MODEL: 2004–2007 NINJA® 250R (EX250-F18/L, F19/L, F6F/L, F7F/L)
TITLE: FUEL TANK LEAK

RECALL

Fairing Bolts:

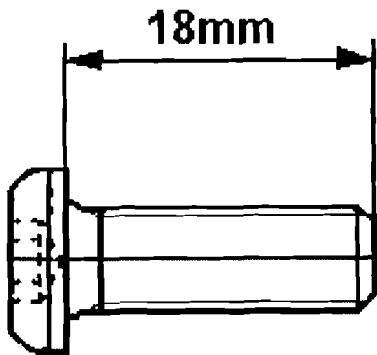
- Remove the left and right upper fairing bolts as shown.

- Check the length of the bolt as shown

Bolt Length	Action
18mm	Retain Bolt & Inspect Fuel Tank
20mm or longer	Replace Bolt & Replace Fuel Tank

- If a 20mm or longer bolt has been used, replace the fuel tank and the bolt(s) with new parts.

- Inspect the fuel tank surface at the bottom of the threaded portion of the upper fairing mounting point. If you find damage to the tank surface, replace the fuel tank. A damaged tank will have one or more of the following defects in the area described for inspection:

- Scratching
- Gouging
- Dimpling
- Cracking
- Fuel leakage
